RELOCATION OF GATES 10 & 11

**PROJECT NO. 54 1019 1765
CONTRACT NO. 54-2-20-2111**

ADDENDUM NO. 1

March 27, 2020

BID DOCUMENTS
DRAWING **AE100**
PROJECT 54 1019 1765
SHEET 87 OF 127

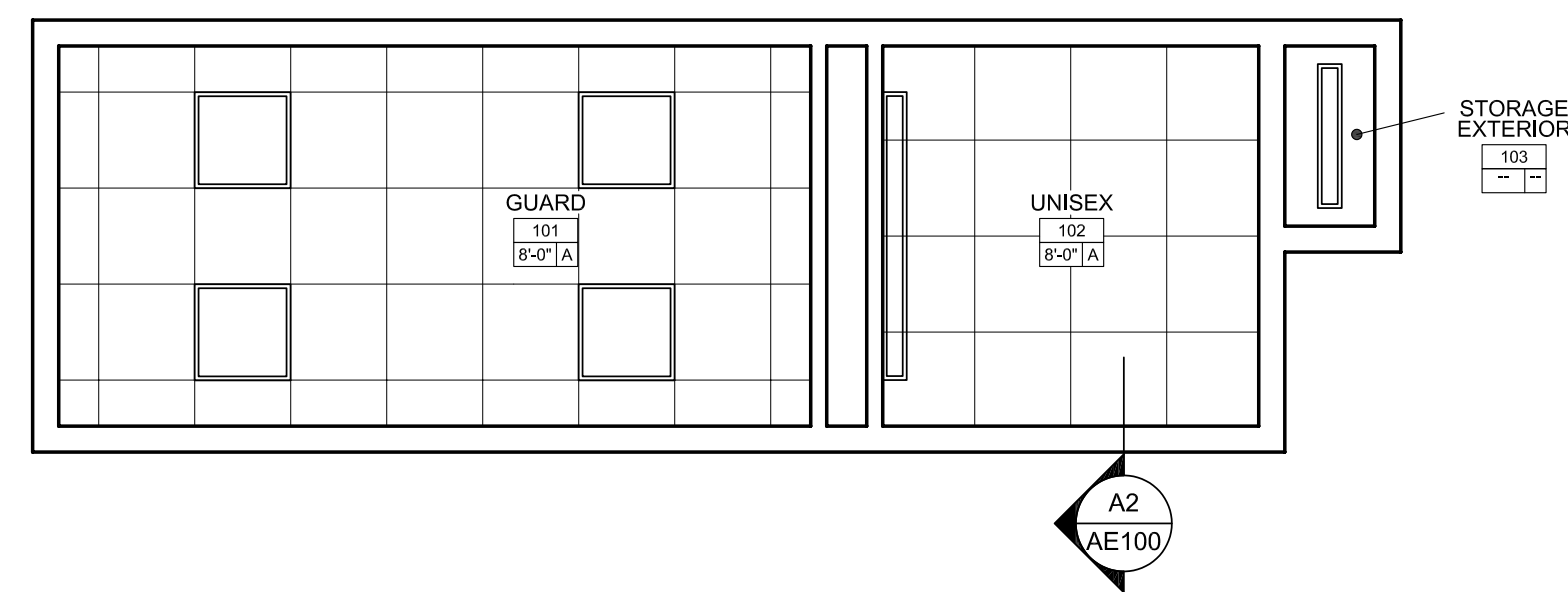
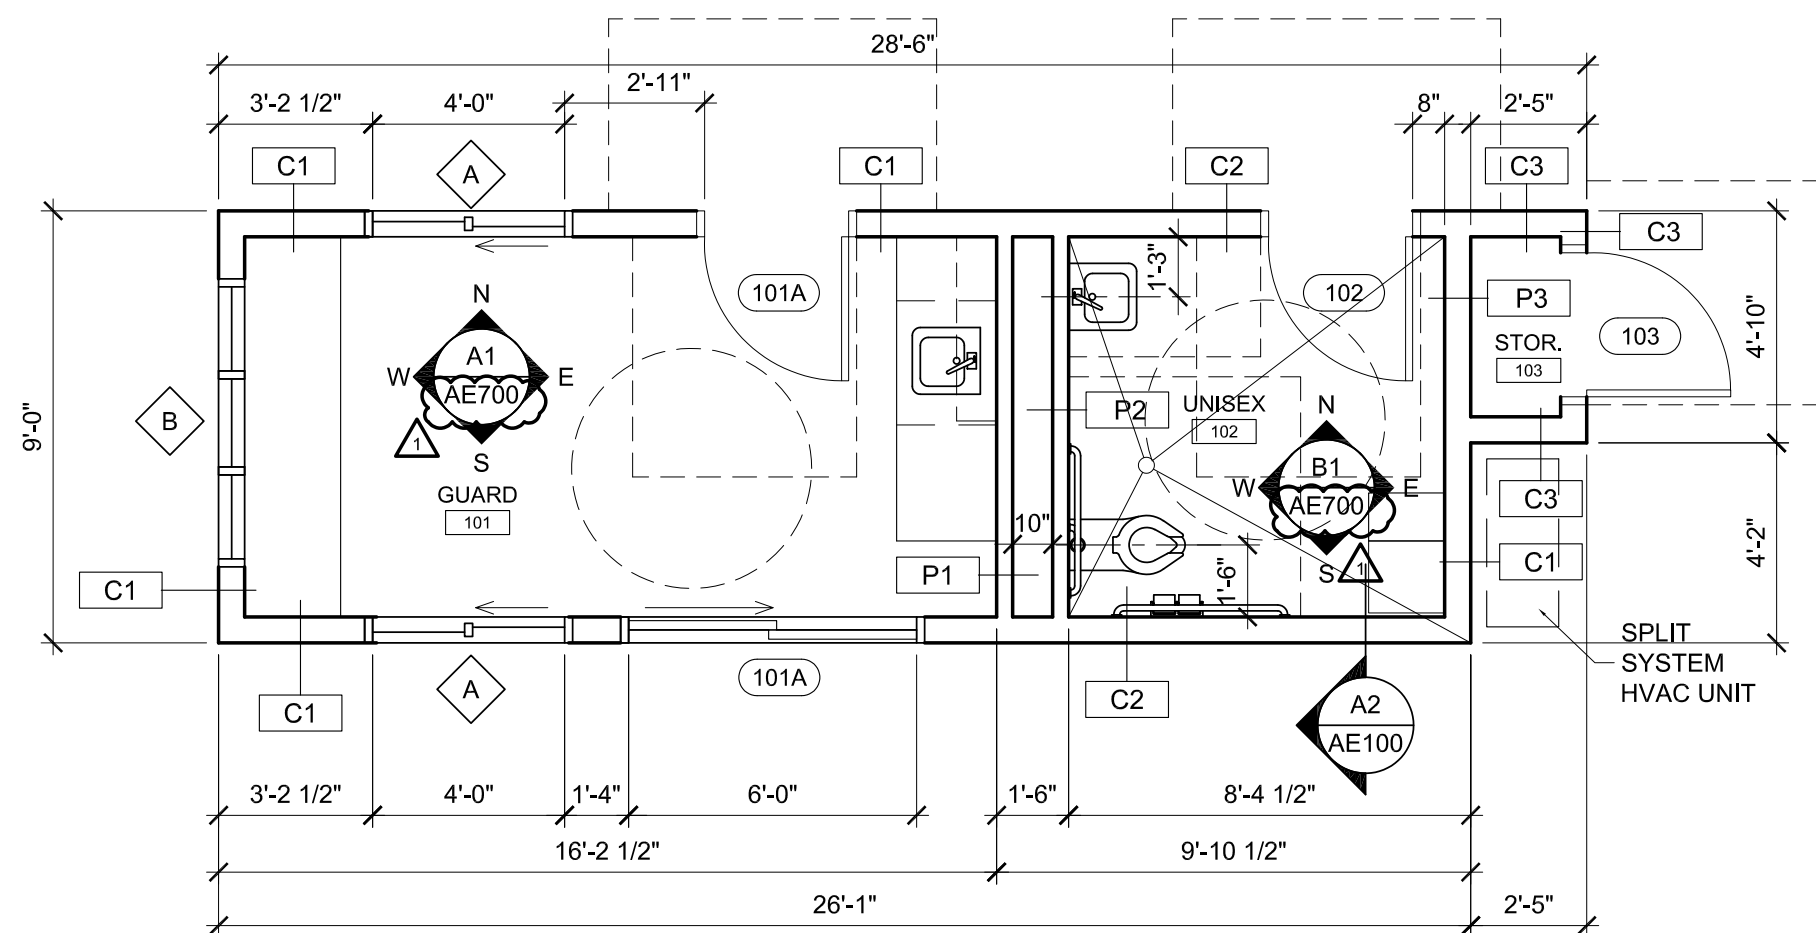
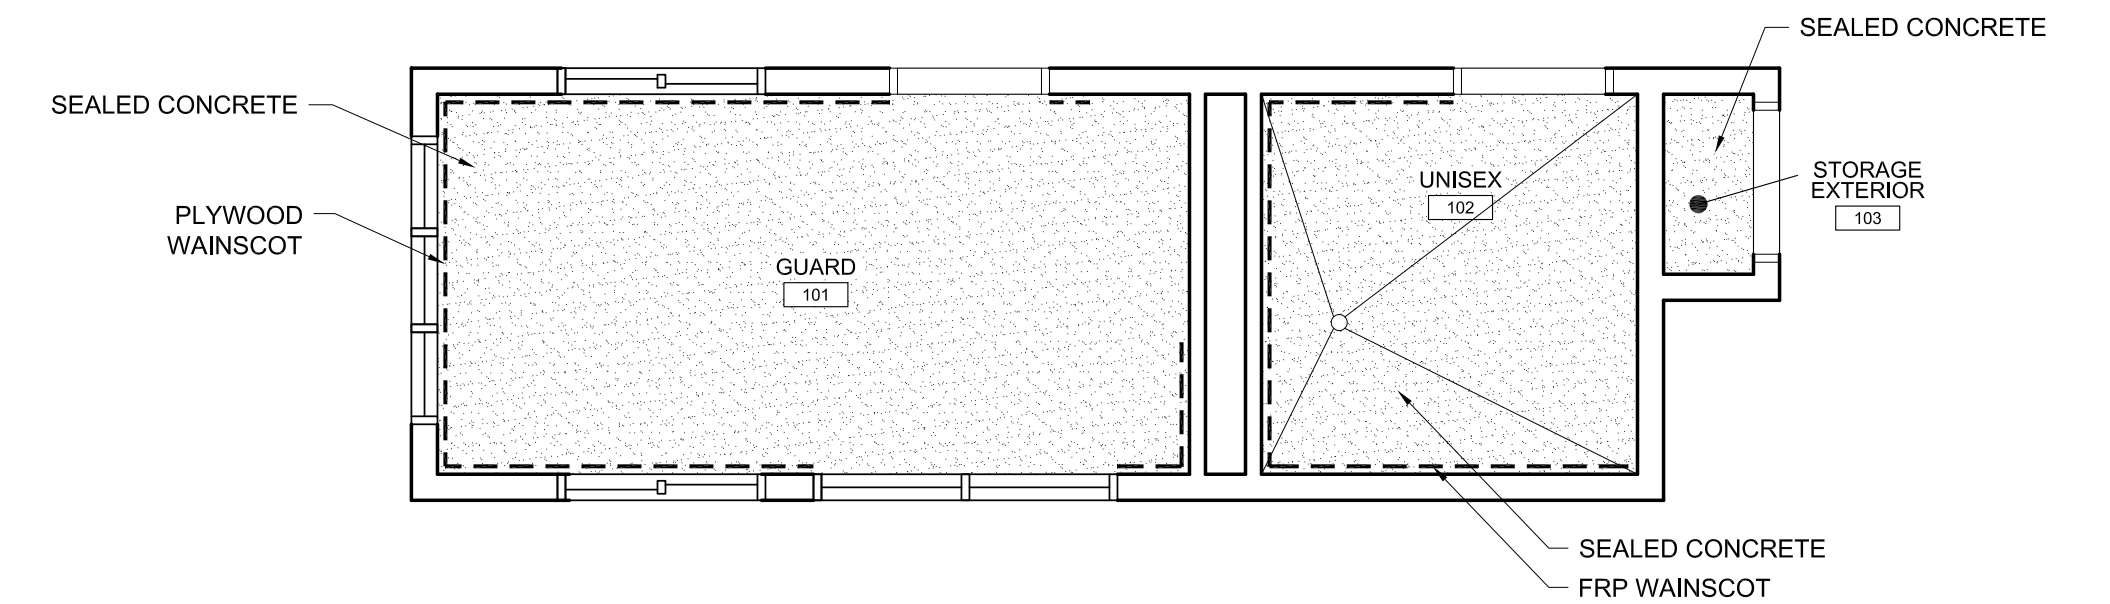
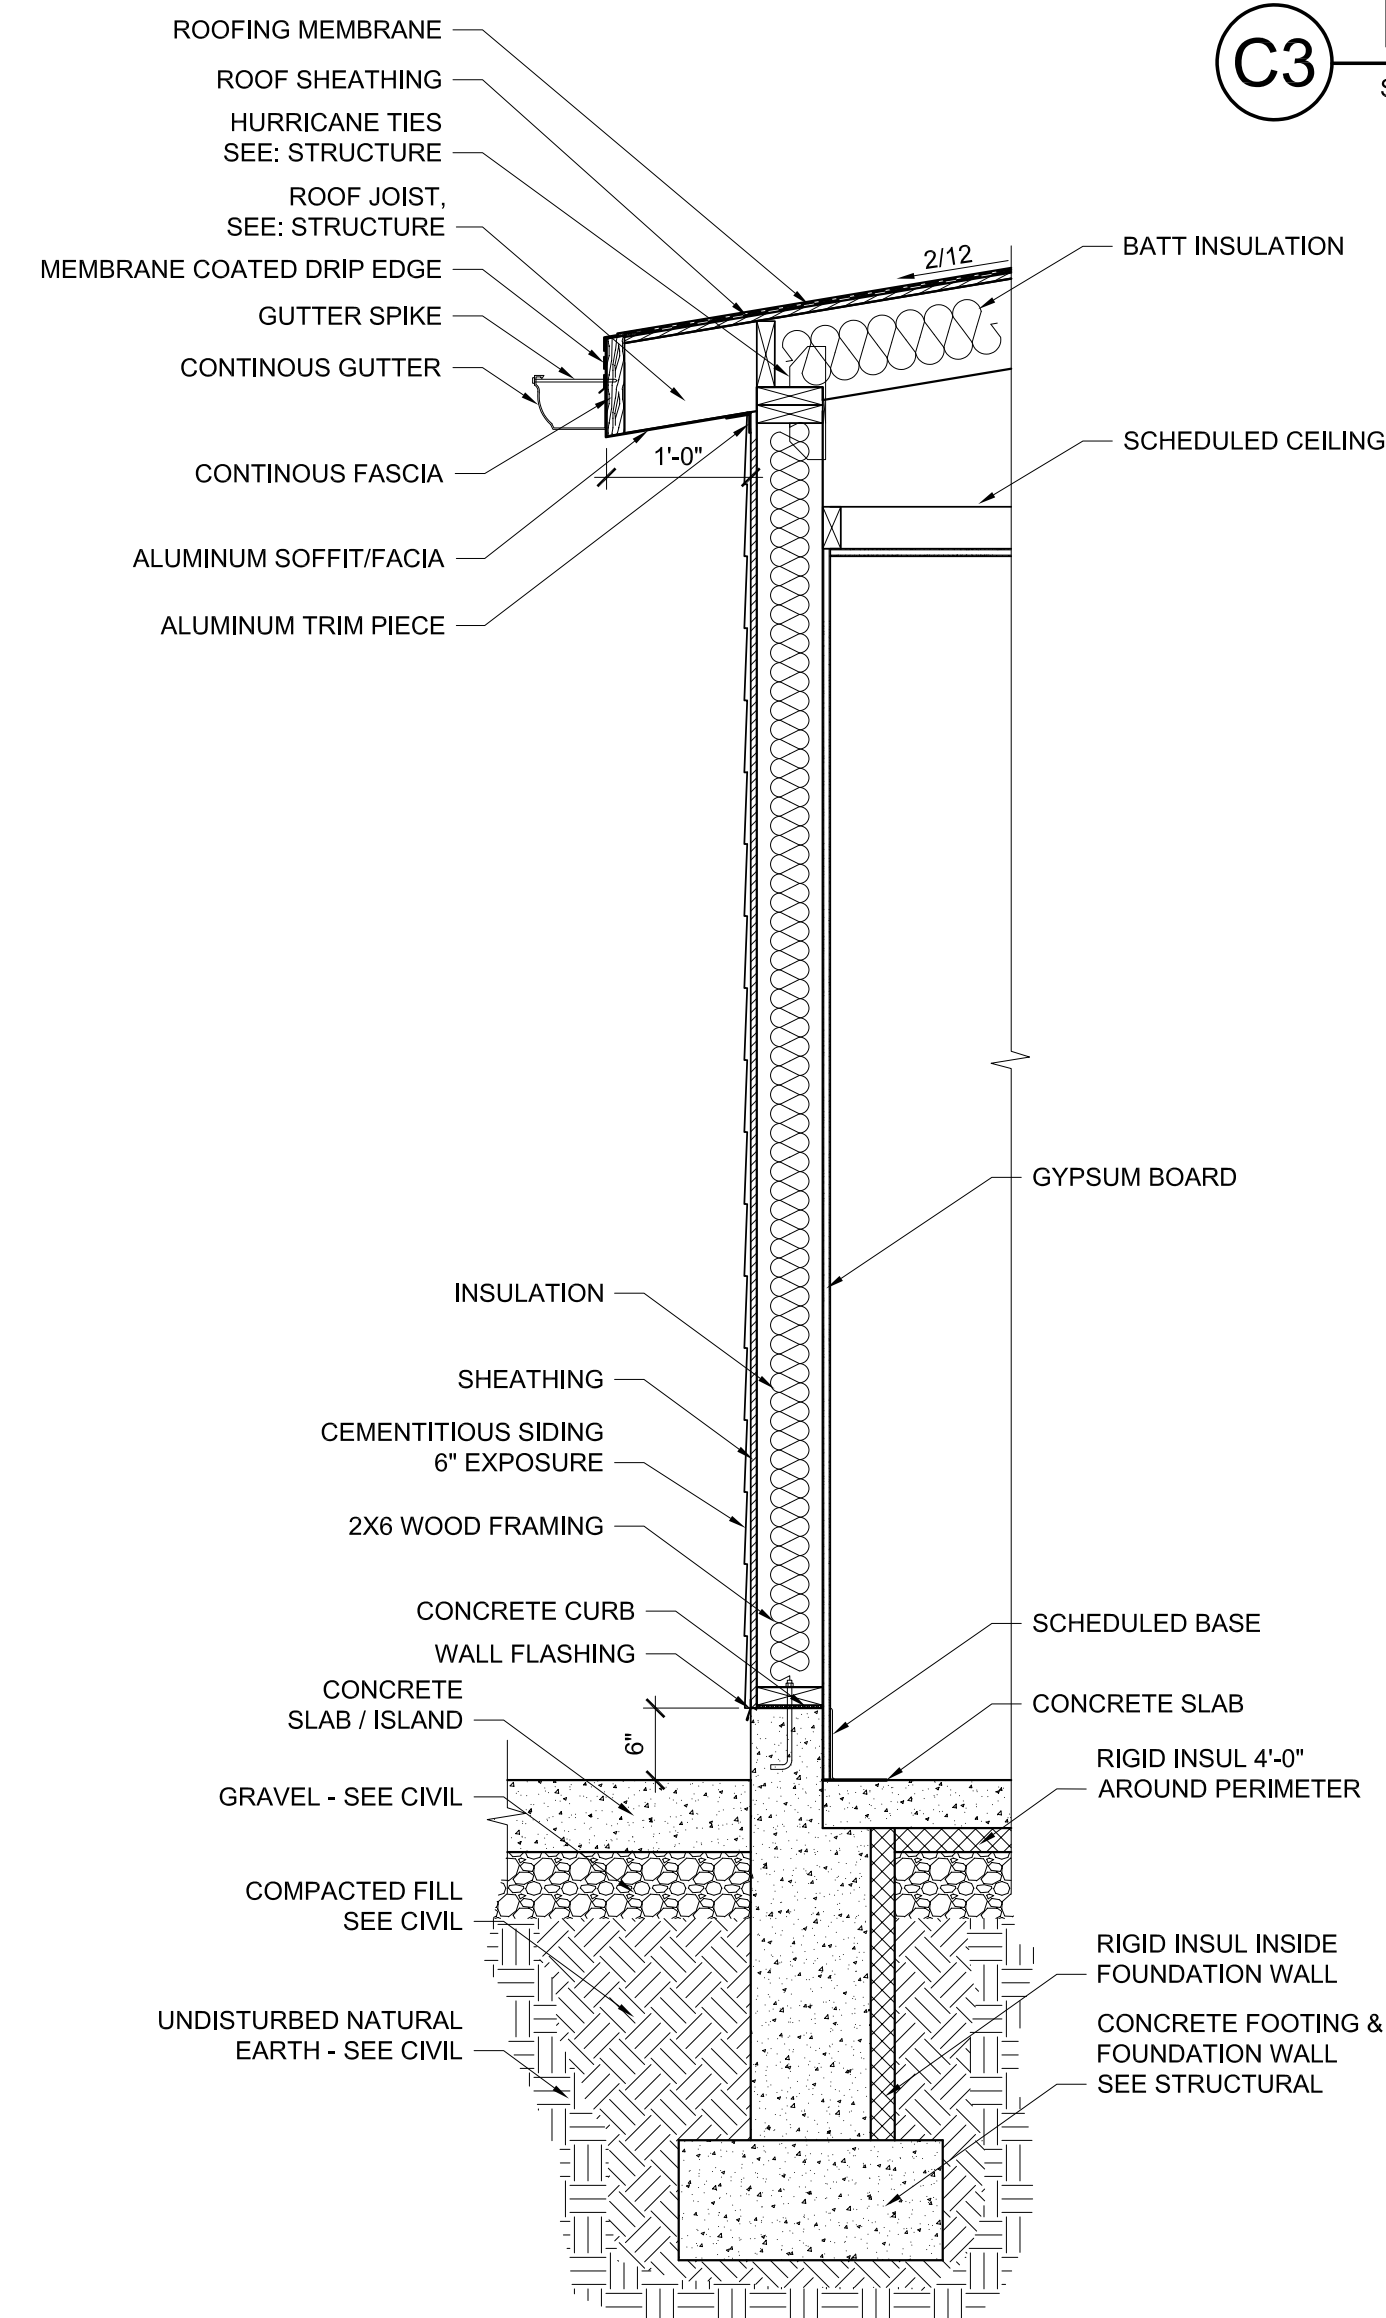
AE100 Addendum No. 1 - Updated interior elevation sheet call out.
